HISTORIC AND DESIGN REVIEW COMMISSION

July 06, 2016

HDRC CASE NO: 2016-248
ADDRESS: 227 WICKES
LEGAL DESCRIPTION: NCB 938 BLK 1 LOT NW 20 FT OF 8 & SE 15.6 FT OF 7
ZONING: RM4 H
CITY COUNCIL DIST.: 1
DISTRICT: King William Historic District
APPLICANT: Milton Porterfield
OWNER: Milton Porterfield, Milton Porterfield
TYPE OF WORK: Landscaping
REQUEST:

Wickes Street

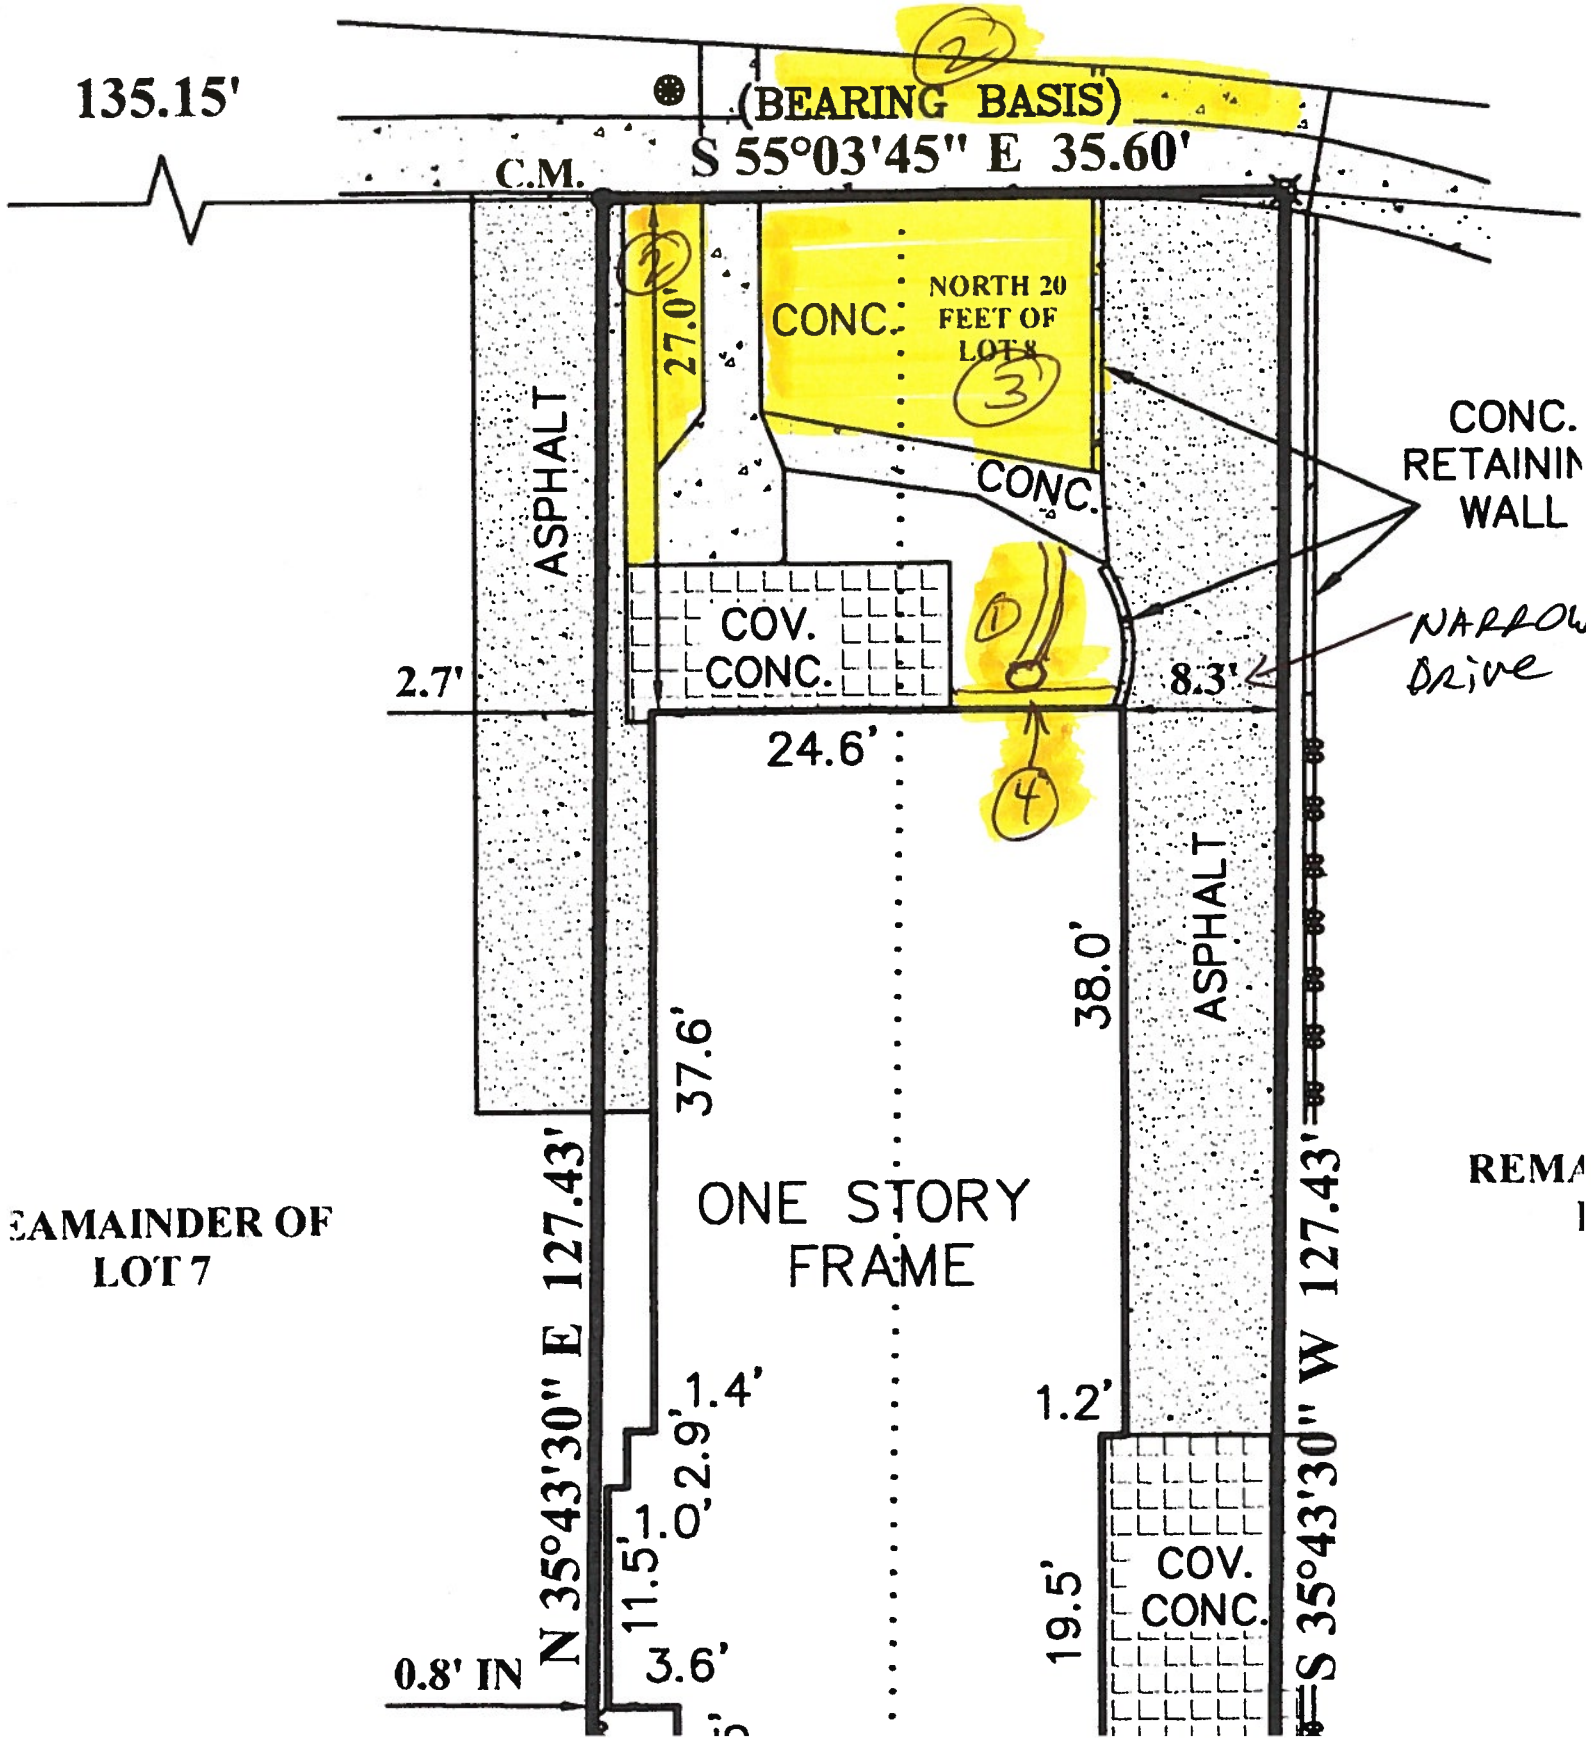
- b. Currently, there is lawn in the area to the right of the front walkway and in the planting strip. The applicant is proposing to install crushed granite in the planting strip and to the right of walkway with no other plantings. According to the Guidelines for Site Elements 3.ii, historic lawns should not be fully removed. Guidelines for Site Elements 3.ii, states that new pervious hardscapes should be limited to areas that are not highly visible and if used, small plantings should be incorporated. This is not consistent with the Guidelines. Staff recommends the applicant plant native xeric plant materials within the crushed granite areas and limit the crushed granite areas to smaller areas.

- c. Currently, there is lawn in the area between the driveway, sidewalk, and front walkway. The applicant is proposing to cover this entire area with lattice pavers and allow grass to grow in between. According to the Guidelines for Site Elements 3 historic lawns should not be fully removed and new pervious hardscapes should be limited to areas that are not highly visible. Staff finds the proposal is not consistent with the Guidelines as the pavers are inappropriate and are highly visible.

- d. Along the driveway is a minimal curb. The applicant is proposing to remove the curb and re-grade the lawn to the right. According to the Guidelines for Site Elements 5, historic curbing should be retained if possible. Staff made a site visit on June 21, 2016, and found that the curbing is not historically found along the block. Staff finds the proposal to remove it consistent with the Guidelines.

- f. In this area the applicant is proposing to pour concrete along house to re-grade and allow water to flow away from the structure. According to the Guidelines for Exterior Maintenance and Alterations 8.A.iii., soil should be sloped

Staff recommends denial of items #1 and 2 based on findings a through c, and recommends the applicant submit a request to install granite beds, and leave 50% green lawn.

Staff recommends approval of items #3 and #4 based on findings d through g with the stipulation that:

1. The applicant submit dimensions of the area to be re-graded with concrete to staff.
